Agenda Item M April 1, 2019

SUBJECT: Approval of the request of TBON, LLC, JSP16-12 for a City Council waiver of Section 5.3.12 of the Zoning Ordinance to allow painted end islands in lieu of the required raised end islands at the end of parking bays that abut traffic circulation aisles, for three locations near the northwest corner of the new addition to the Suburban Collection Showplace to allow for improved loading operations, and other modifications as shown on the revised Final Site Plan.

Suburban Collection Showplace Expansion
JSP 16-12

Revised Final Site Plan

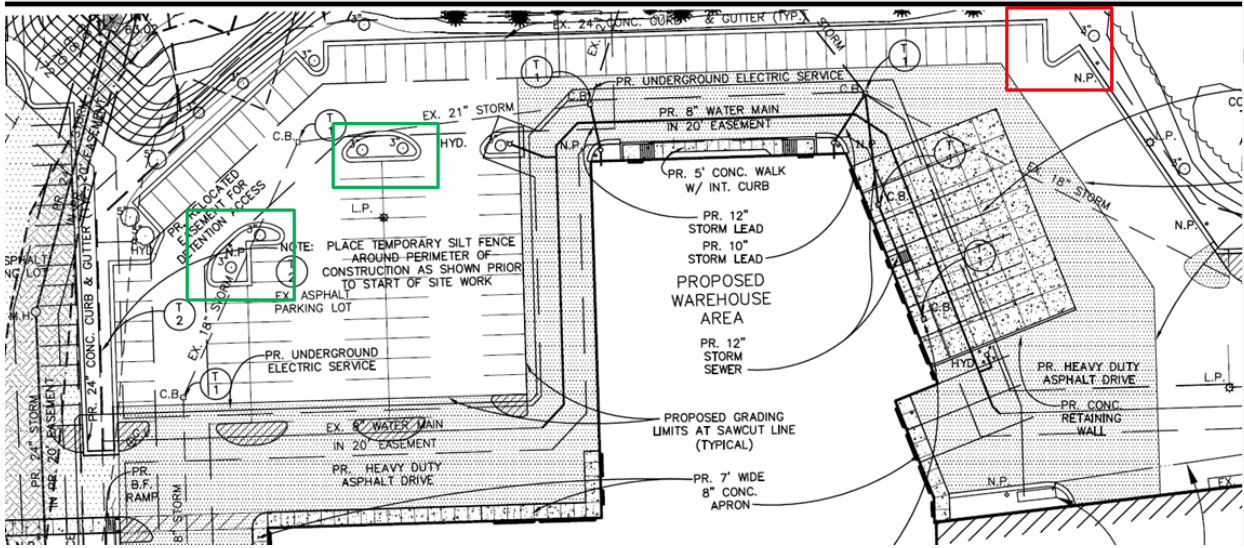
To accommodate the proposed secondary uses, the applicant is proposing a flat paved area with no interior parking lot islands to allow for the greatest flexibility in "test course design", similar to existing ride and drive lot previously approved on the eastern side of the site. A striping plan has been submitted but the applicant has indicated the automotive research users have requested the area either remains un-striped or that it be striped in a muted color. The Overall Master Site Plan shows two additional "Expansion Parcels" to the west, but they were not part of the site plan approval. **The current site plan reflects the changes made on site during construction which were not part of original approval.**

2. Additional Pavement off-site: The Overall Master Site Plan, Sheet C-1 shows two additional "Expansion Parcels" to the west, but they were not part of the site plan approval. The previous site plan showed a part of the access road on parcel 2 (Tax Map ID: 22-16-176-021). However, the applicant has paved approximately 70 feet of additional surface area along the west edge on Parcel 2. The applicants cover letter dated January 24, 2019 indicates that this additional pavement is added as part consideration for the for the then land contract holder to provide the permanent joint access/reciprocal easement required by the City for access to storm water basin. **The previously existing gravel paving on Parcel 22-16-176-021 was considered a non-conforming condition of the property as it has been used in the past. The gravel paving area had also been used for outside storage and use for suburban showplace outdoor events as approved under special permits. Paving the area is considered an improvement to the existing non-conforming surface, and the pavement has been accounted for in the calculations for storm water management.**

SHEET NO: **L-1**

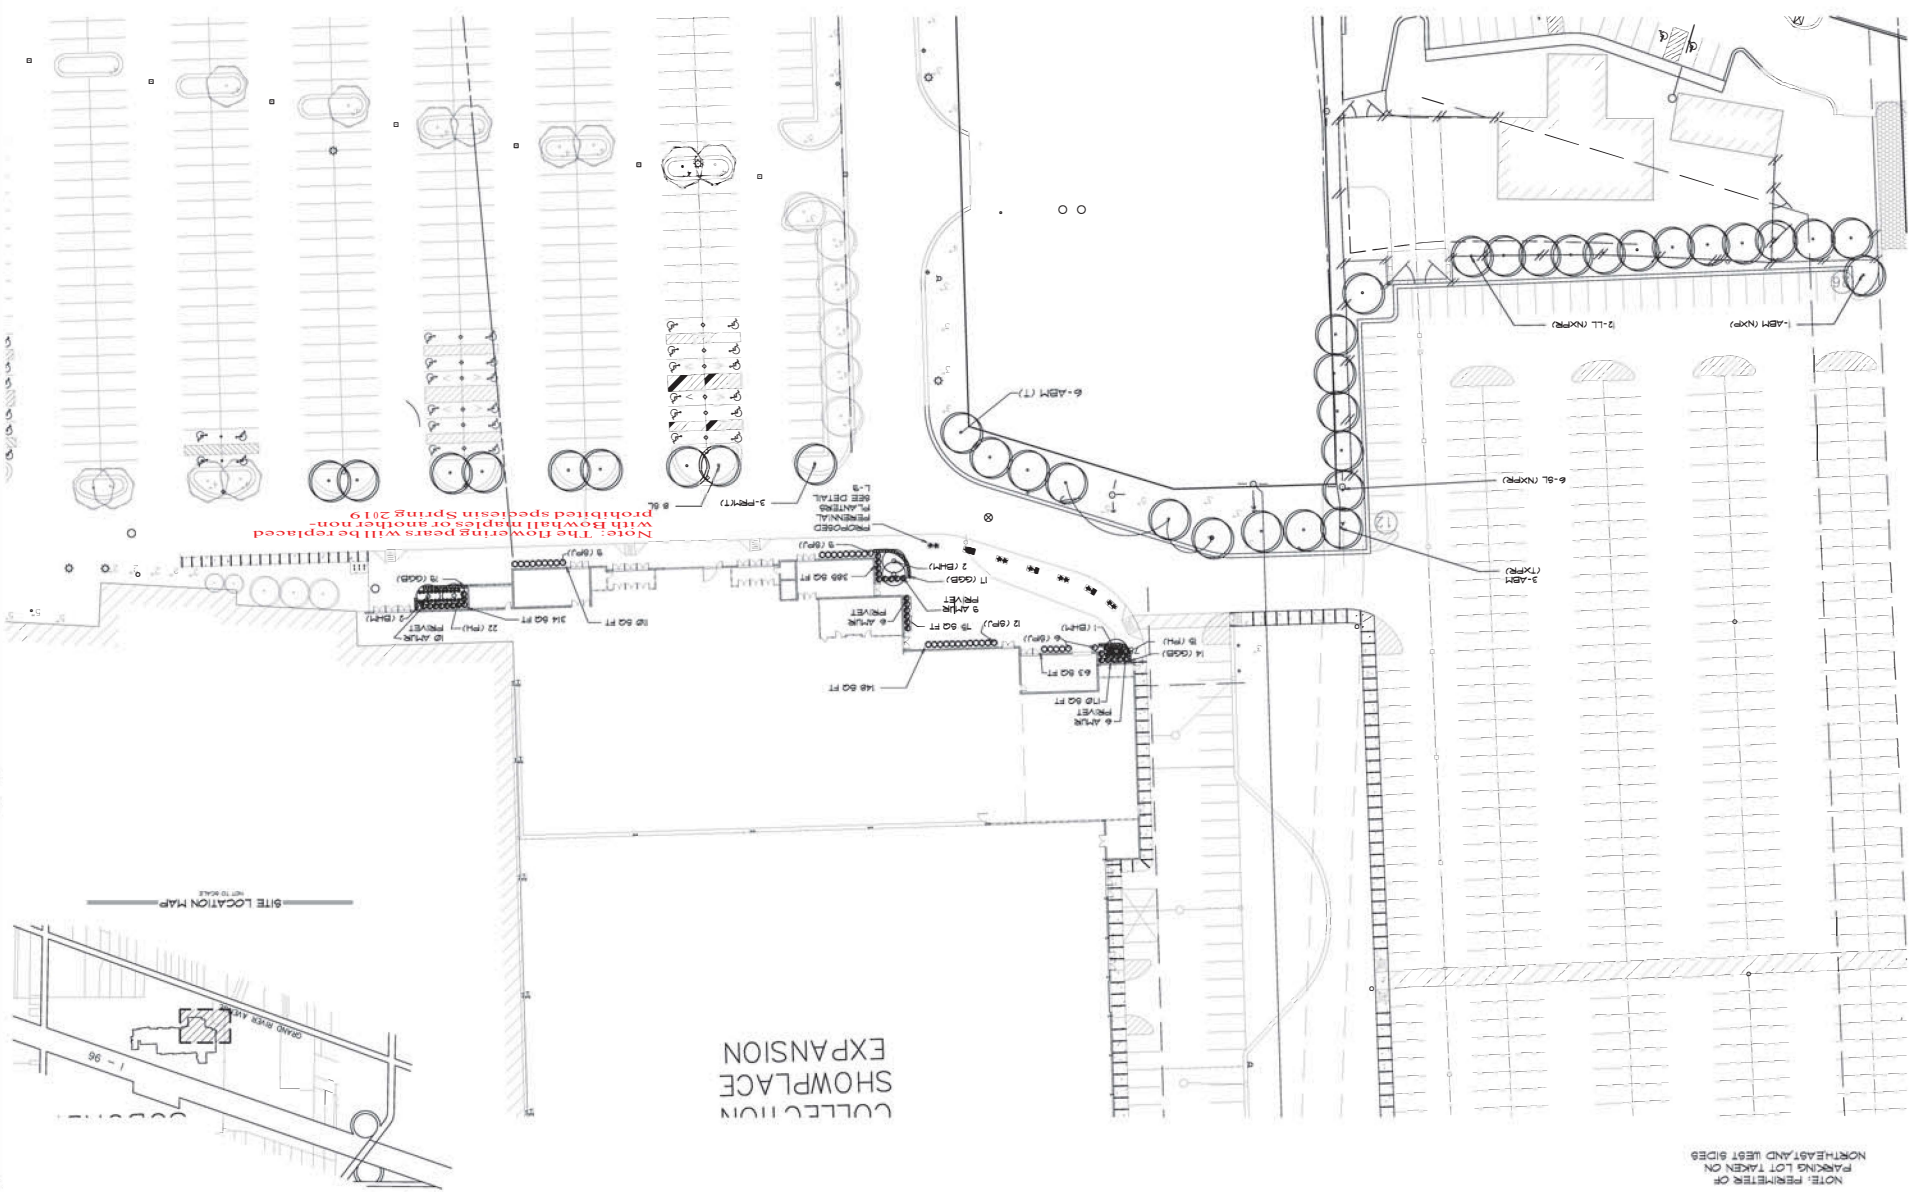
1. Add 4 deciduous canopy trees to replace those lost in the two endcap islands that were removed to provide better maneuvering for traffic using the western door on the north side of the addition. Two should be within 15 feet of the curb along the north edge of the parking lot/access drive, and 2 in the long island between the two parking lots.
2. Please show all existing trees to remain, proposed trees and relocated trees on Sheet L-2 to provide a complete record of plantings for future reference. This will be an as-built if the trees have already been planted or transplanted.

We have also included updated landscape plans with the requested notations made. These landscape plans are submitted in accordance with the Consultants comments, and it is agreed that a site walk will occur in the Spring 2019 after all plantings/replantings have been complete. A final marked up as-built will be completed at that time for the file.
